To Bruce Brunswick 626-564-9672

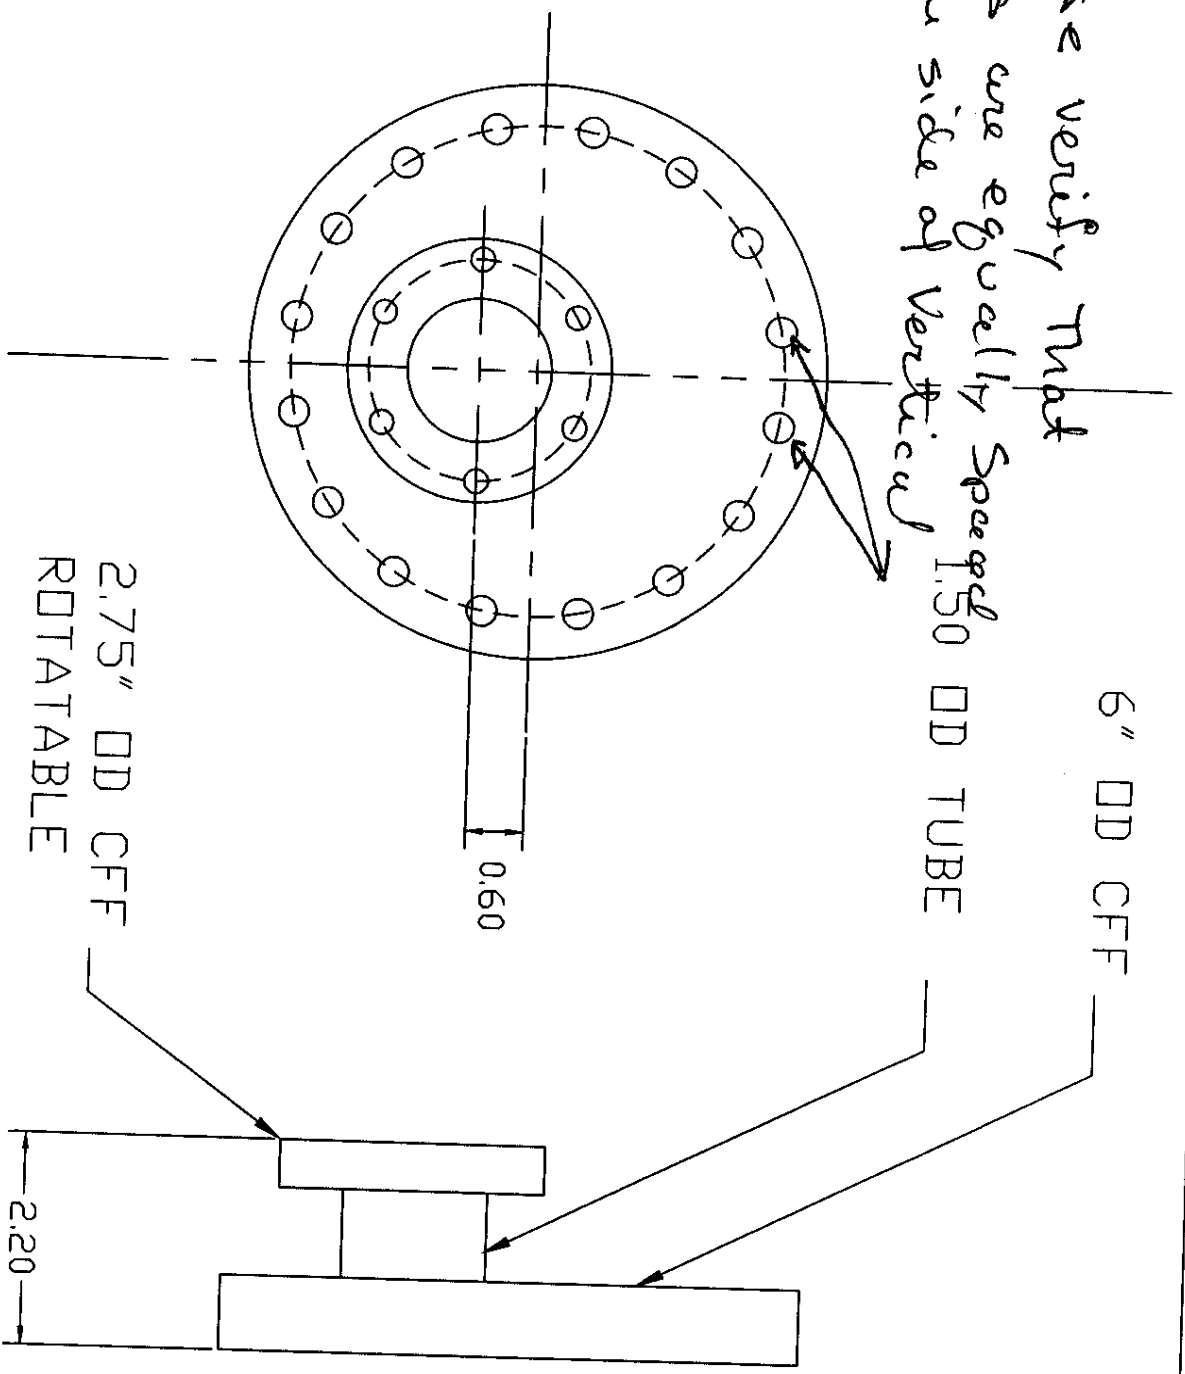
Please verify that
 Holes are equally spaced
 each side of vertical
 6" OD CFF
 1.50 OD TUBE
